TOLEDO - LUCAS COUNTY PLAN COMMISSIONS

REF: SUP25-0023

SUBJECT: Request for a Special Use Permit for a Cultural Exhibit at 1600 Mott Avenue

Request	-	Amendment to Special Use Permit, Originally Granted by Ord.143-24, for Polish Cultural Center
Location	-	1600 Mott Avenue (parcel #1627991)
Applicant/Owner	-	Tom Waniewski Polish Cultural Center Advisory Board PO Box 291 Waterville, OH 43566
Engineer	-	Troy Barman Verdantas LLC 219 S Erie Street Toledo, OH 43604

LANDSCAPE PLAN

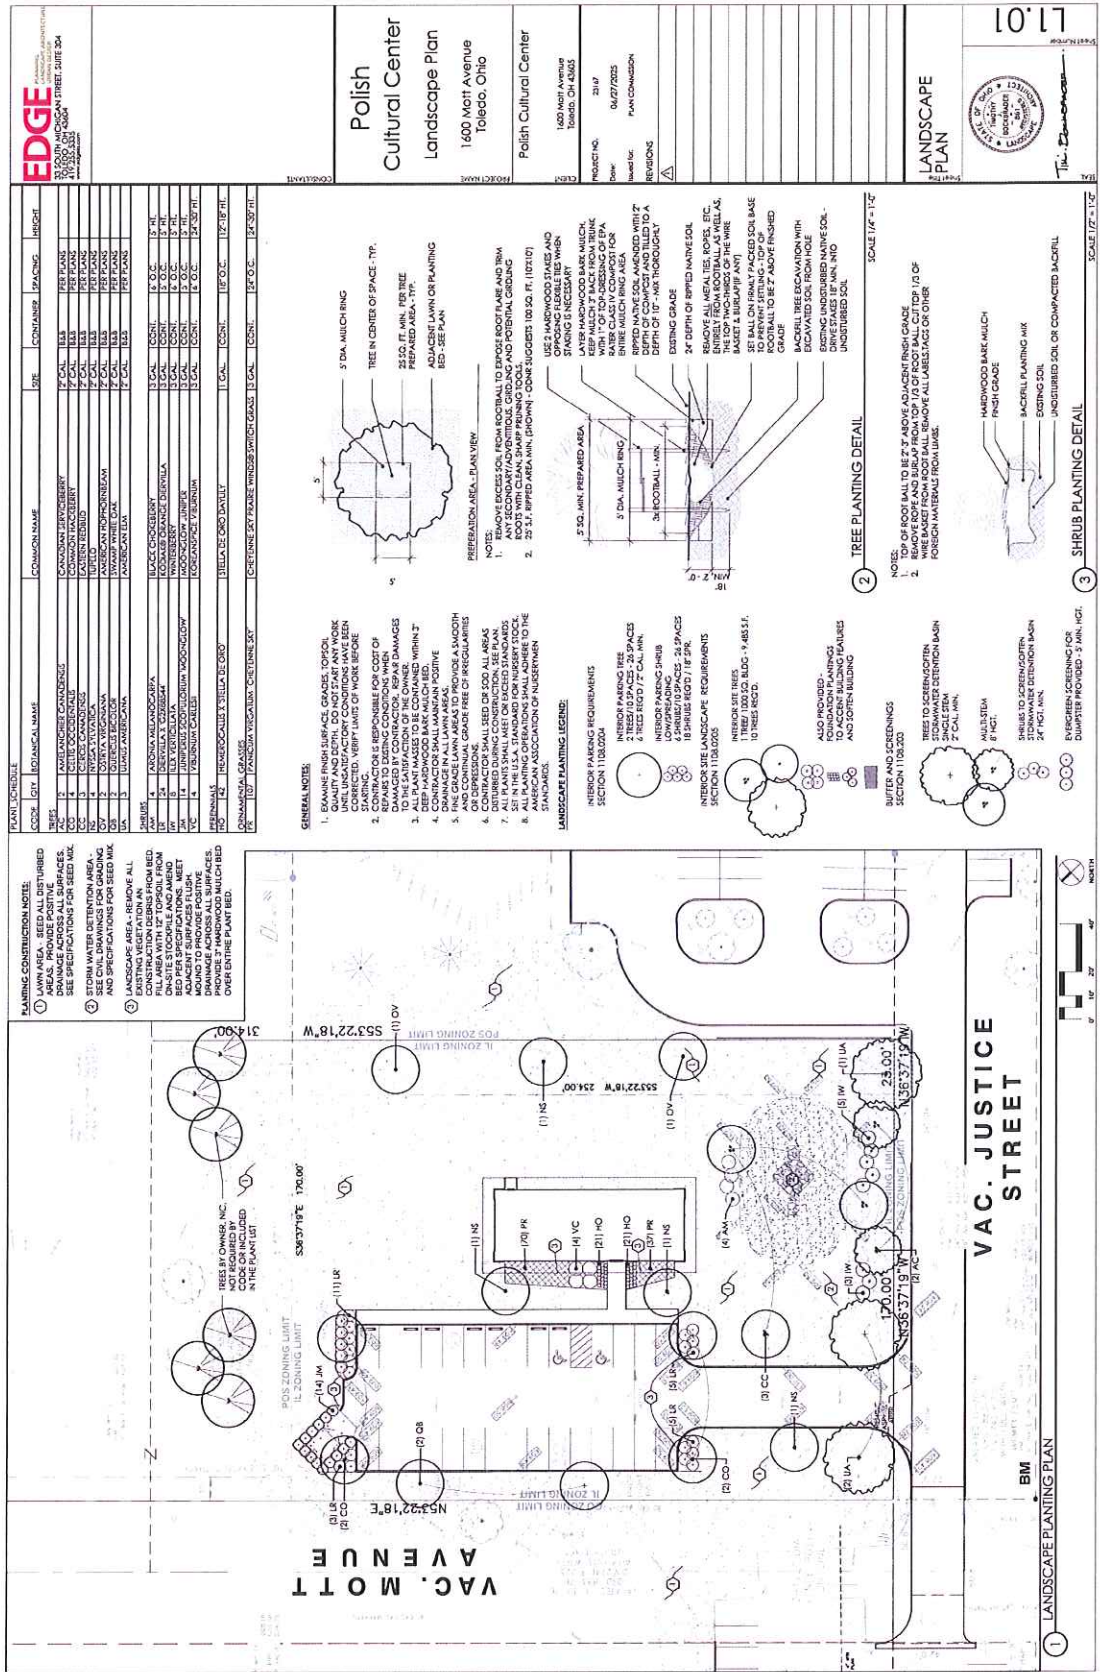
Bicycle parking is required pursuant to Off-Street Parking Schedule "A" (TMC§1107.0300). A minimum of one (1) bicycle space shall be provided per ten (10) automobile parking spaces. The parking lots contain a total of 26 spaces, requiring at least three (3) bicycle parking spaces. The submitted site plan does not depict any bicycle parking; this omission shall be addressed in revised site plans and is listed as a condition of approval.

Furthermore, the POS zoning distinction does not trigger any screening requirements between abutting properties as per TMC§1108.0203 – *Buffer and Screening Requirements*. However, the site plan depicts a greenbelt along the southwestern edge of the parcel to screen the proposed stormwater detention basin. This greenbelt is comprised of five (5) trees and a continuous shrub row and is acceptable as depicted. Screening comprised of five-foot (5') evergreens is also depicted surrounding three (3) sides of the proposed dumpster. These plantings will be accompanied by a fence or wall structure surrounding all four (4) sides of the dumpster, as required by TMC§1108.0203(G), and shall be shown on a revised plan.

Interior parking lot plantings, as specified in TMC§1108.0204, must provide two (2) canopy trees and six (6) shrubs for each ten (10) parking spaces. With twenty-six (26) proposed spaces, the required interior planting area must be comprised of at least six (6) trees and sixteen (16) shrubs. The current site plan depicts six (6) trees and twenty-four (24) shrubs and is acceptable as depicted. In addition, perimeter parking lot plantings are required to visually screen parking facilities from view of Residential districts and public right-of-ways. A minimum of at least one (1) canopy tree must be provided for each thirty (30) linear feet, plus a continuous shrub with a minimum height of eighteen (18) inches. Plans depict adequate perimeter parking plantings to screen the parking lot from the Residential district to the southwest.

Finally, interior site landscaping requirements specify that the site plan must provide one (1) two-inch (2") caliper tree for every 1,000 square feet of building coverage. Three (3) trees are required at minimum. The landscaping plan meets the requirements for interior landscaping with the provision of fourteen (14) trees, in addition to the required parking lot landscaping. The plan also depicts foundation plantings to frame the entranceway to the building.

33. Per TMC§1107.0400, Off-Street Parking Schedule “A” requires one (1) bicycle parking slot per ten (10) parking spaces. **Not acceptable as depicted on site plan. A bike rack with a minimum of three (3) slots shall be provided on revised plan.**

- a. Dumpster location(s) shall be clearly defined, have a concrete pad and be screened on all four sides by any combination of evergreen plantings, fence, or wall structure and shall not be located in any required setbacks or the public right-of-way as stated in TMC§1361.10(b)(10) of the Building Code. **Not acceptable as depicted. The plantings depicted on the site plan will be accompanied by a fence or wall structure surrounding all four (4) sides of the dumpster, as required by TMC§1108.0203(G) and shall be depicted on a revised site plan.**

- g. If the site is ½ acre or larger, landscaped areas must be irrigated as necessary to maintain required plant materials in good and healthy condition. Irrigation plans must be submitted with development plans and must contain all construction details; **Not acceptable as depicted; applicant shall provide irrigation plans for the site as it is larger than ½ acre.**
